DEYOUNG SUBDIVISION

SITE GRADING & EROSION CONTROL PLAN

MS-20-001

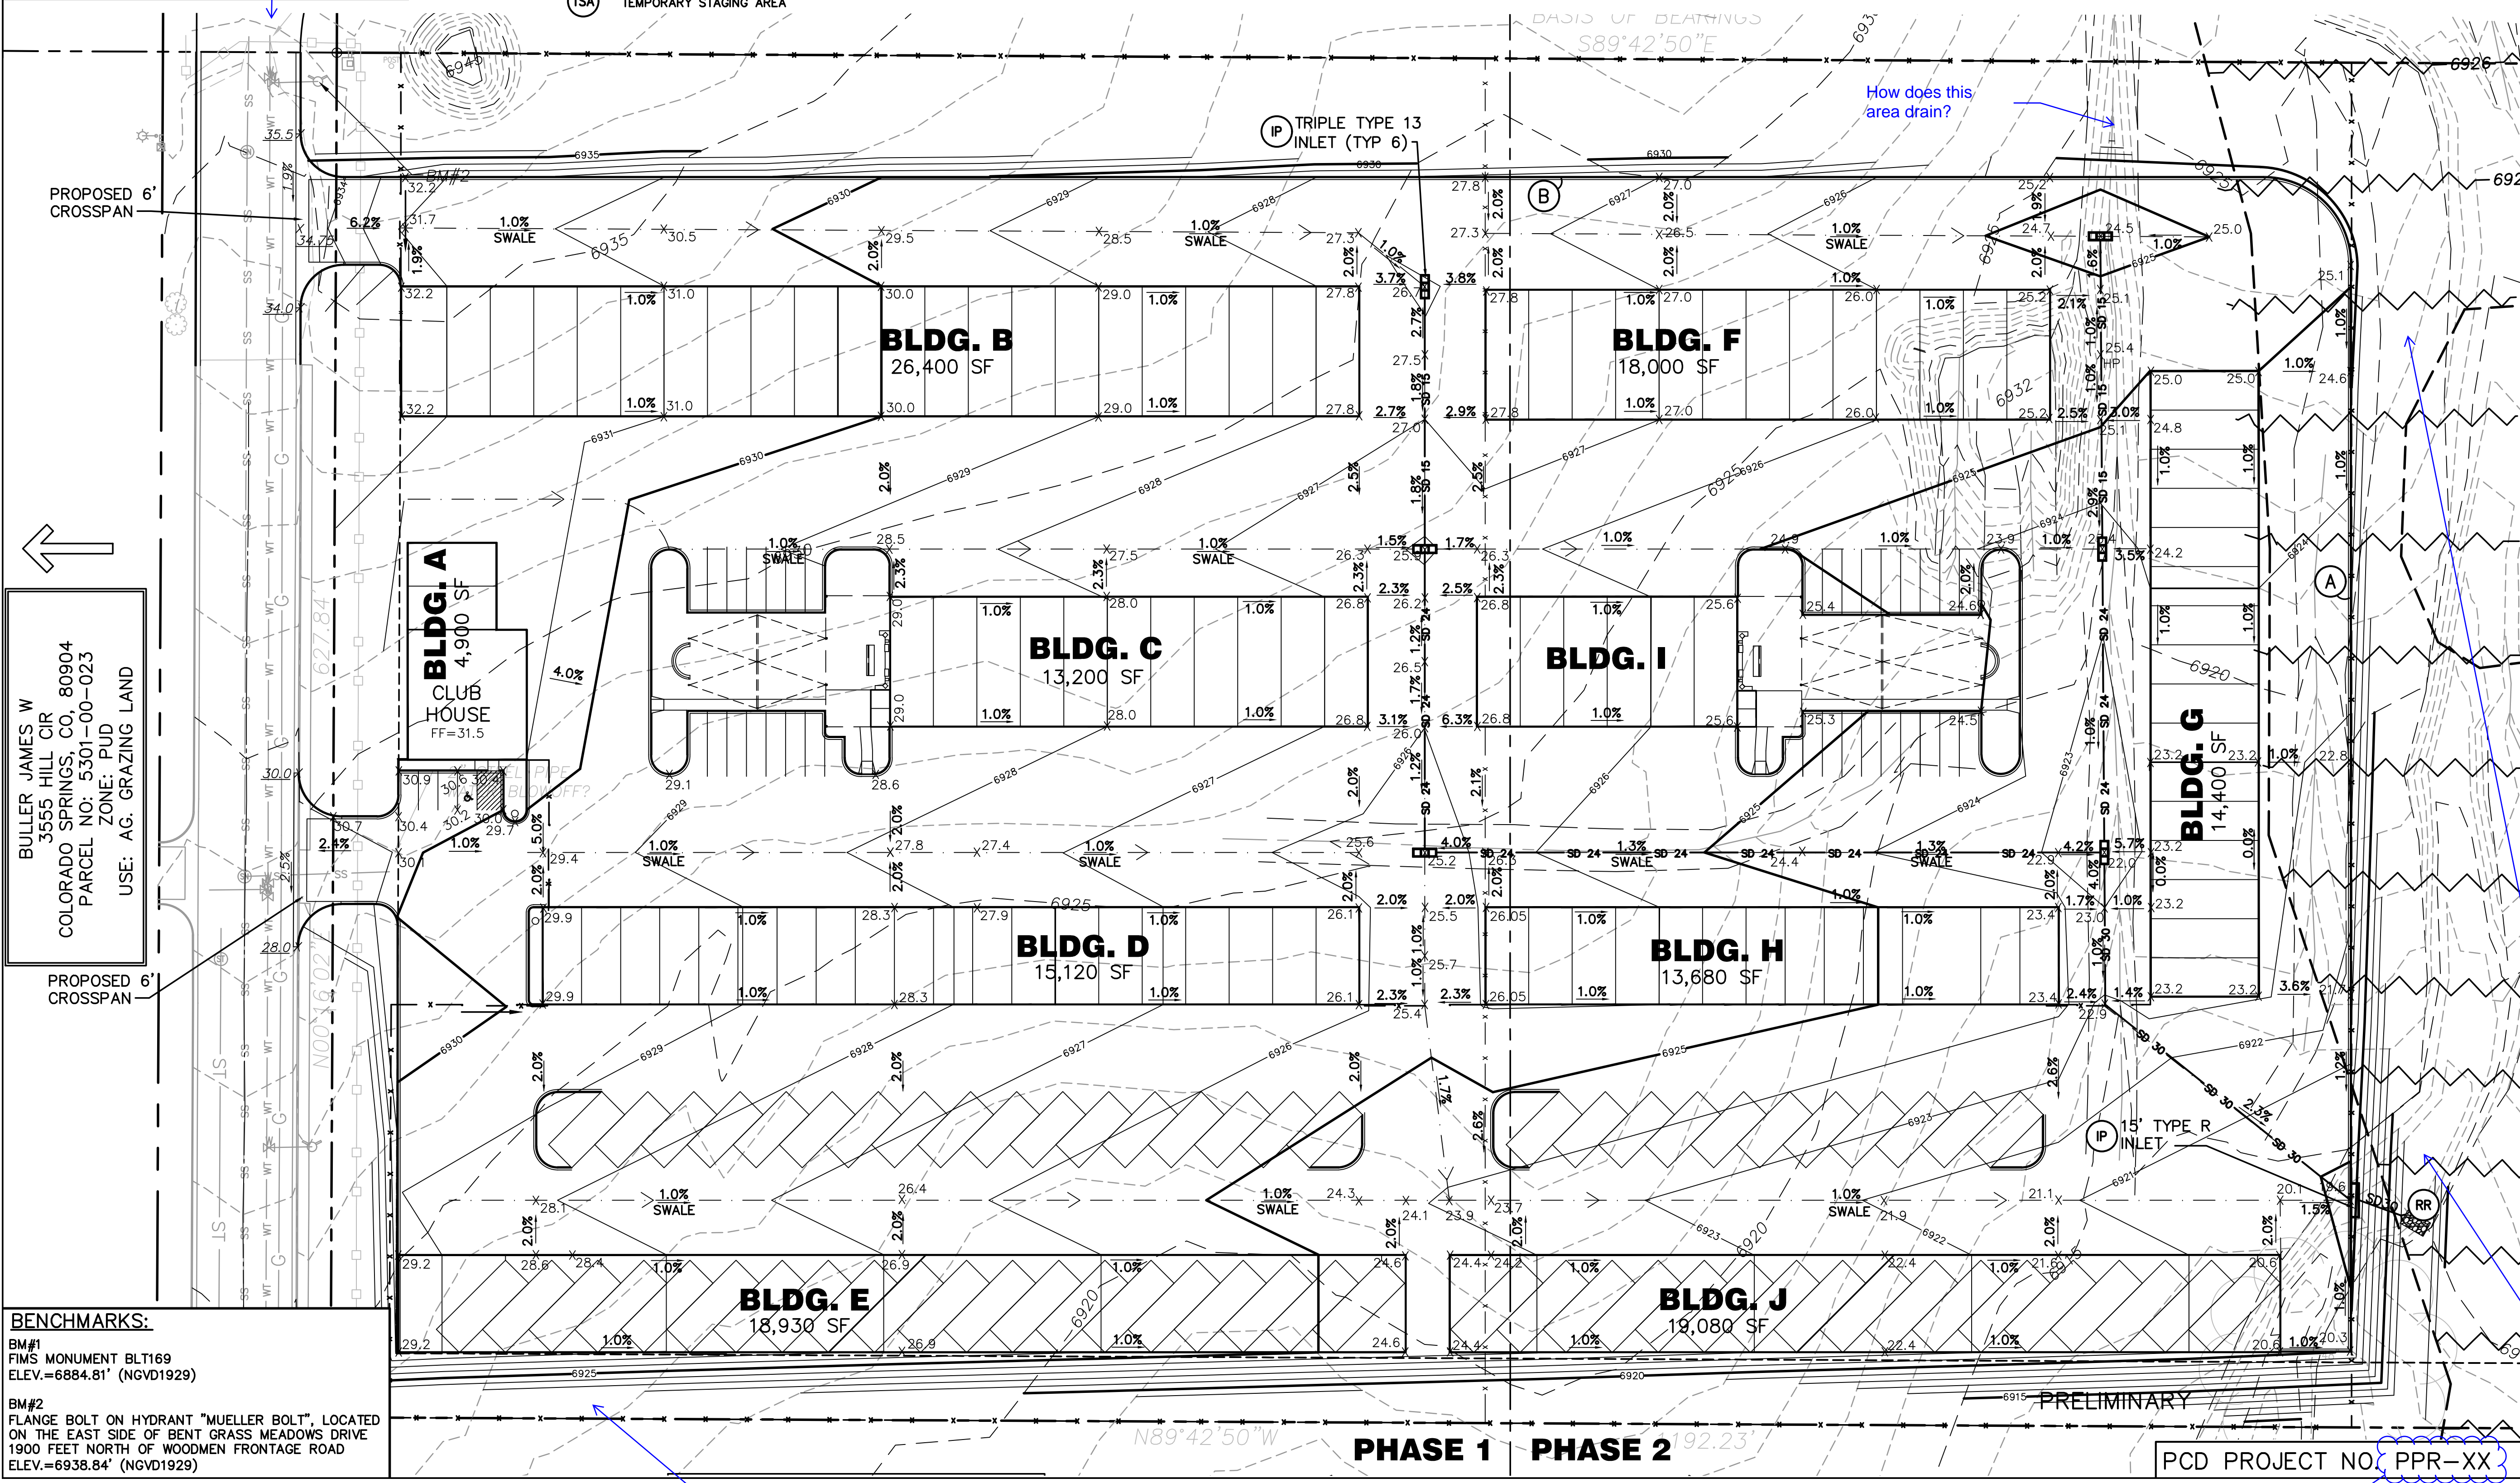
Show all temporary and permanent BMPs

is there no on-site drainage facility? The geo report identifies one?

Changes to the floodplain require FEMA approval of CLOMR / LOMR. Modeling needs to be provided in the FDR. Address timing of construction and provide Phase 1 plan.
